DOCKET 50-255 - LICENSE DPR-20 - PALISADES PLANT - CORRECTION FACTOR FOR  
IRRADIATION TEMPERATURE BELOW 525° - PRESSURIZED THERMAL SHOCK - 10CFR50.61 -  
ADDITIONAL INFORMATION

This letter transmits a corrected Page 1 and a corrected Figure 1. The first  
page and Figure 1 of our April 2, 1992 letter on this subject should be replaced  
with the enclosed corrected first page and Figure 1.

Figure 1

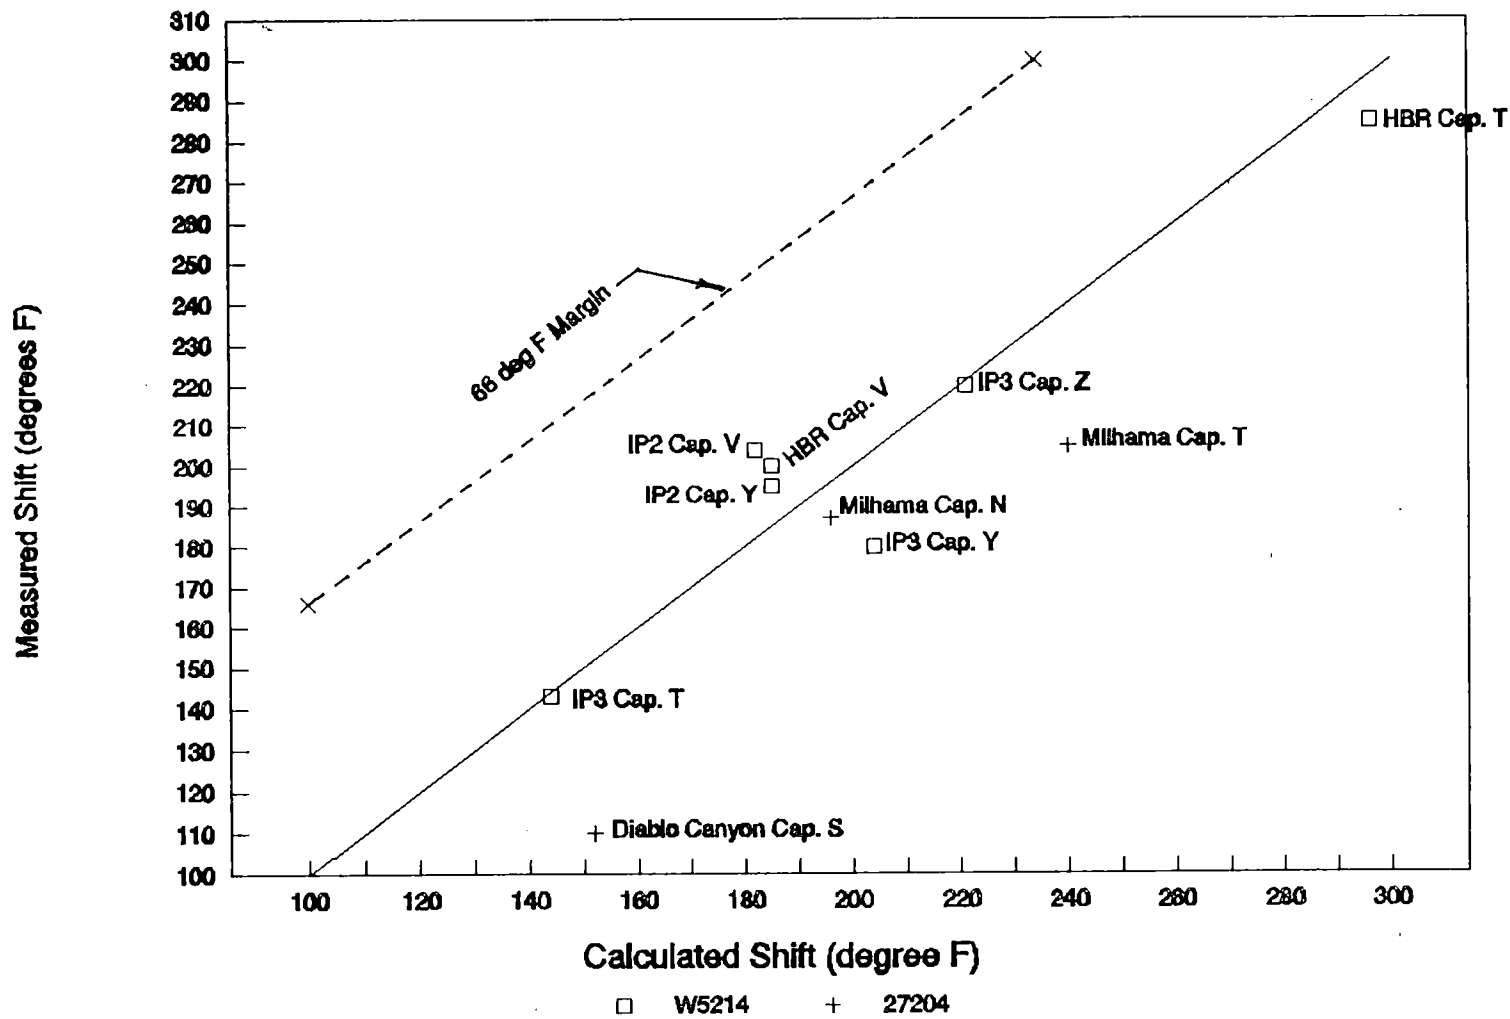
Revision 1, dated April 2, 1992, of Consumers Power Company's March 11, 1992  
letter contained a typographical error on the first page (234°F as the estimated  
future T-Cold instead of the correct value of 534°F) and inadvertently changed  
the heat number for one group of data points plotted in Figure 1 to 34B009  
instead of leaving the correct heat number 27204 intact.

**SUMMARY:** Corrects typographical error on Page 1 (was 234°F instead of the correct 534°F estimated T-Cold) and corrects heat number on Figure 1 (was 34B009 instead of the correct 27204).
